From: BRYAN Martin (EXTERNAL AREVA) [Martin.Bryan.ext@areva.com]
Sent: Tuesday, August 24, 2010 7:46 AM
To: Tesfaye, Getachew
Cc: KOWALSKI David (AREVA); Hearn, Peter
Subject: FW: DRAFT RESPONSES FOR FSAR Chapter 9 Weekly NRC Telecon
Attachments: Blank Bkgrd.gif; DRAFT RESPONSE RAI 351 Q.09.02.05-22.pdf; DRAFT FSAR Changes RAI 351 Q.09.02.05-22.pdf

Request for Additional Information No. 351, Supplement 2

U.S. EPR Standard Design Certification
AREVA NP Inc.
Docket No. 52-020
SRP Section: 09.02.05 - Ultimate Heat Sink
SRP Section: 09.05.01 - Fire Protection Program

Question 09.02.05-22:

Figure 2.7.11-1—Essential Service Water System Functional Arrangement
Sheet 1 of 9

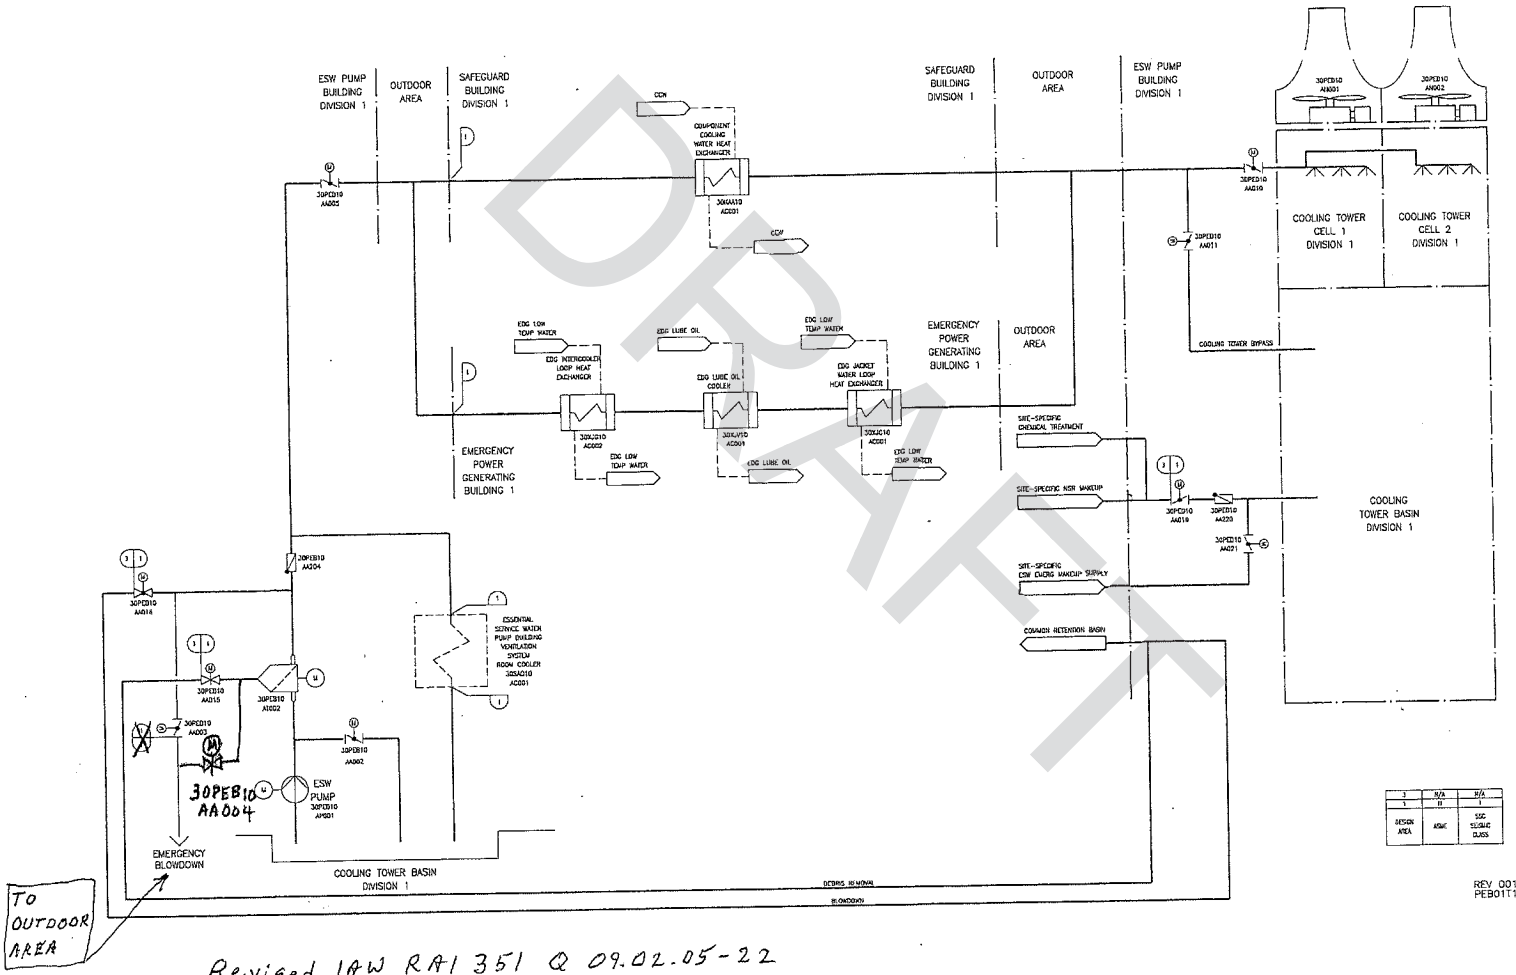
To ensure the function of the safety related filter, an alternate filter blowdown is provided as shown in the FSAR Figure 9.2.1-1 being revised. The new line includes valve 30PEB10/20/30/40AA004, Filter Emergency Blowdown Isolation Valve.

Revised IAW RAI 351 Q 09.02.05-22

Figure 2.7.11-1—Essential Service Water System Functional Arrangement
Sheet 3 of 9

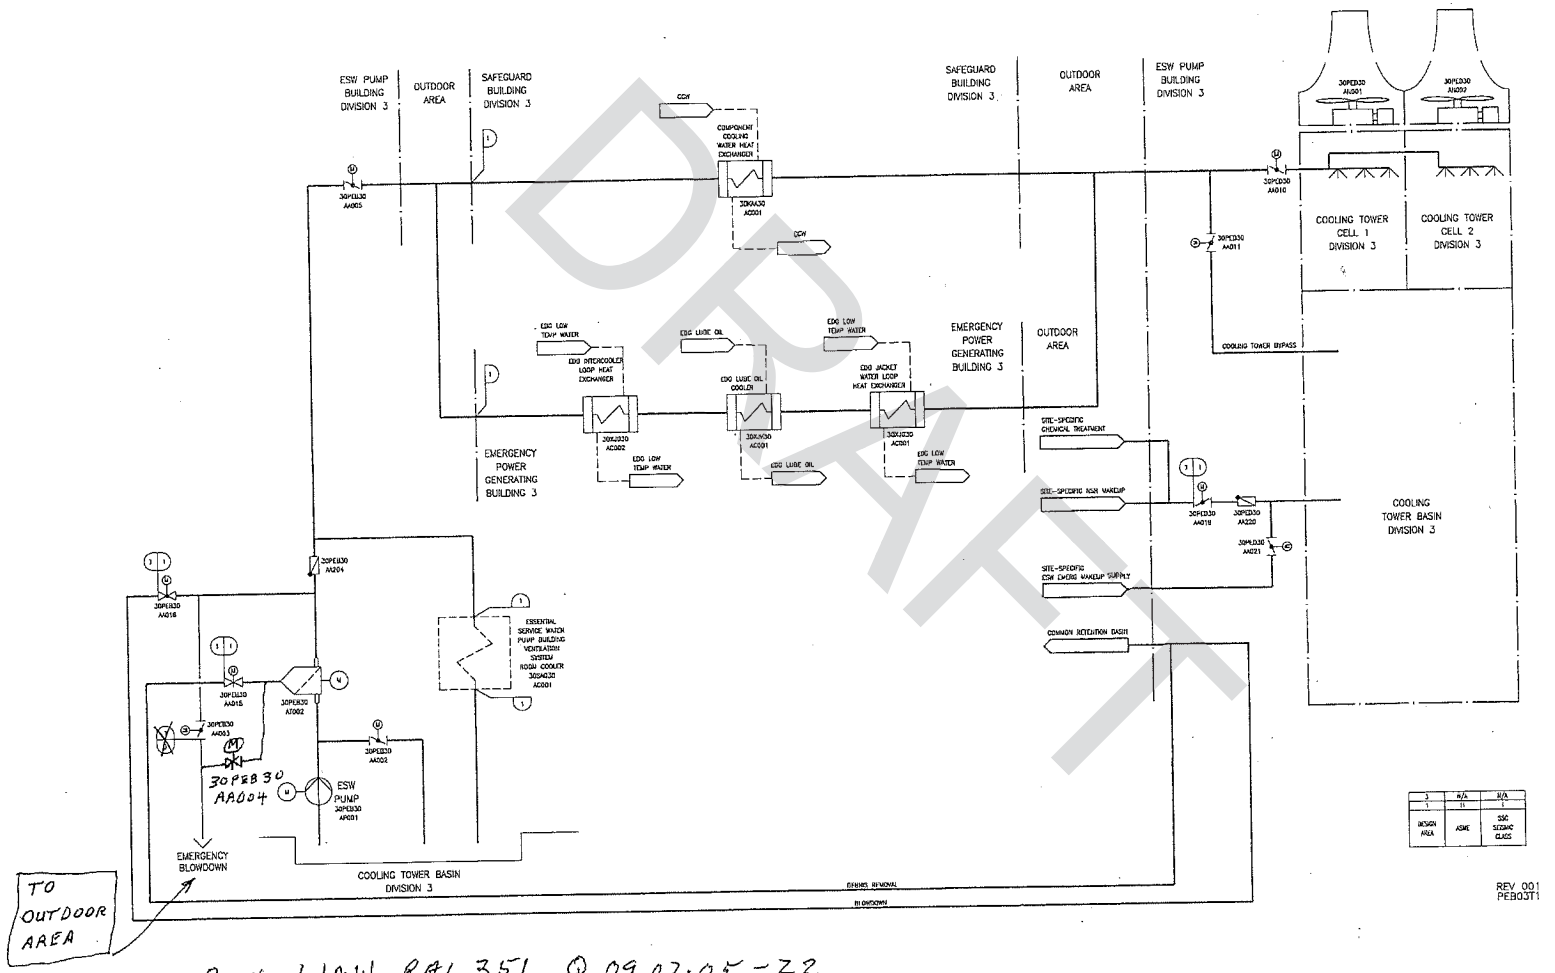
Revised IAW RAI 351 Q 09.02.05-22

Figure 9.2.1-1—Essential Service Water System Piping & Instrumentation Diagram
Sheet 1 of 4

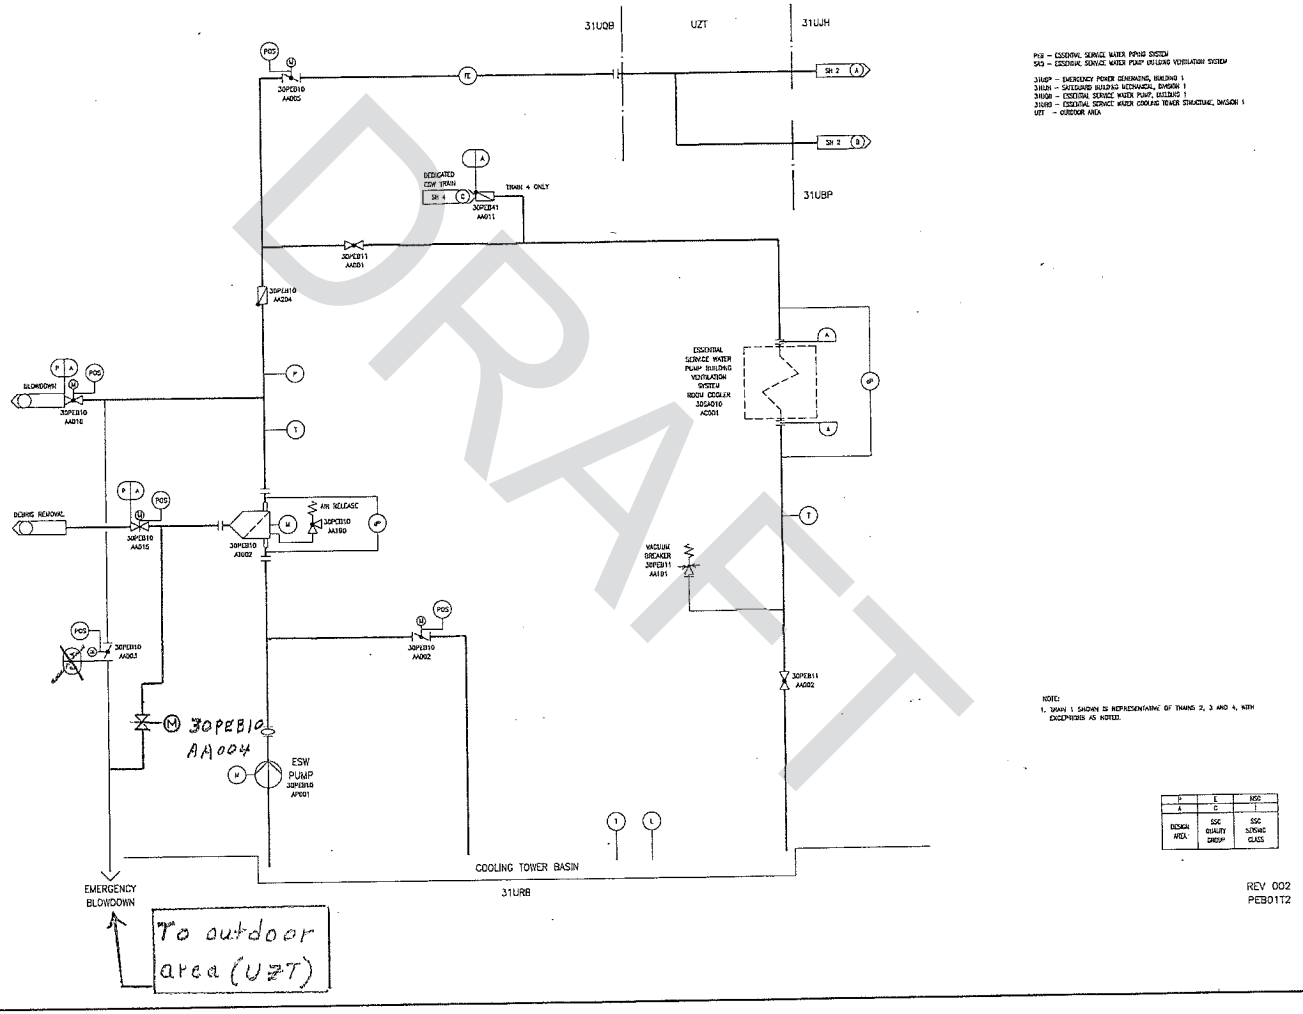
As shown in the revised FSAR Figure 9.2.1-1 the complete emergency blowdown flow path is classified as safety related to assure its functional availability during any design basin event. The emergency blowdown discharges outside of the building and is located above the flood level. Emergency blowdown piping exiting the building is protected from tornado generated missiles. The missile protection is provided by either shielding at the interface with outside emergency blowdown system or by buried piping.

Revised IAW RAI 351 Q 09.02.05-22

To ensure the function of the safety related filter, an alternate filter blowdown is provided. The line includes valve 30PEB10/20/30/40AA004, Filter Emergency Blowdown Isolation Valve.
